**Summary Report of Visit to LIGO, Caltech:**                      **January 25<sup>th</sup> – February 25<sup>th</sup> 2004**  
Michael Perreur-Lloyd

**Subject:** Re: Summary Report of Caltech Visit January/February 2004  
**From:** Michael Perreur-Lloyd <m.perreur-lloyd@physics.gla.ac.uk>  
**Date:** Mon, 15 Mar 2004 19:28:35 +0000  
**To:** Dennis Coyne <coyne@ligo.caltech.edu>  
**CC:** Michael Perreur-Lloyd <m.perreur-lloyd@physics.gla.ac.uk>, Caroline Cantley <c.cantley@physics.gla.ac.uk>, Jim Hough <j.hough@physics.gla.ac.uk>, Janeen <janeen@ligo.caltech.edu>, Calum <ctorrie@ligo.caltech.edu>, Norna <norna@fastloki.stanford.edu>, Justin GreenHaulgh <J.Greenhalgh@rl.ac.uk>, Ken Strain <k.strain@physics.gla.ac.uk>

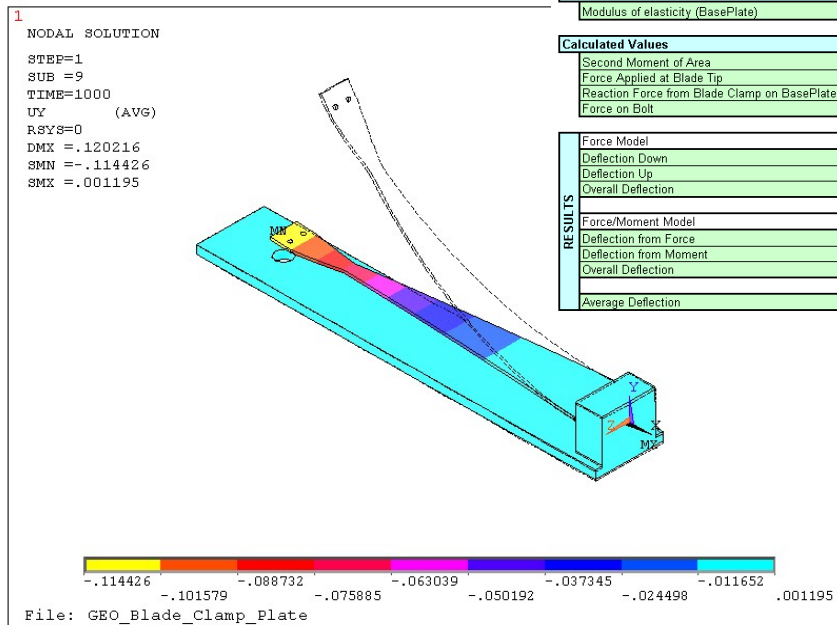
I had a few comments/questions about your very nice trip report, related to the blade deflection analysis. I was surprised that the Ansys analysis of the blade deflection was so much larger than the experimental results. Was this a linear or nonlinear analysis? Did you confirm convergence by increasing the mesh size? What element was used? What is contour plotted in the Ansys results figure?

Thanks for comments on my report. Prior to releasing my report, Calum and I had discussed whether or not to show the results seeing as they were not completely conclusive as far as the FEA was concerned. These additional comments should hopefully explain the reason for the slightly erroneous Ansys results.

The blade-clamp-plate tests were done primarily for me to fully understand the previous work done by Dan Mason and John Veitch. The Ansys analysis was tacked on in some respect as an exercise in finding how easily we could import a SolidWorks model into Ansys Workbench, apply two different materials (blade and clamp were steel; Plate was aluminium) and turn out a result that at least fell in the region of those from the experiment and calculator. As this work was done prior to the analysis of the QuadX19 structure and with this being one of my earlier trial uses of Ansys Workbench, the 'basic' mesh was most probably chosen.

So, in answer to your questions: This was a simple linear analysis; No, I did not study the effect of increasing the number of elements and look for a convergence in the results; and The contour plotted in the screenshot shows Total deformation. I realise now that I should have made this clearer in the report.

Incidentally, you may have noticed, that the screenshot shown in my report was in fact one from Ansys Classic. This was a further test where we were checking the effect of opening up a file in the Classic environment that was originally created in Workbench. For your information the results after solving in Classic were almost identical to those from Workbench (within a tenth of a mm).

As I mentioned in the report the work will be continued as I develop the Top and Upper-Intermediate Mass designs. When I start that work in the coming weeks I intend to begin by remodelling the blade-clamp-plate with a more advanced mesh.
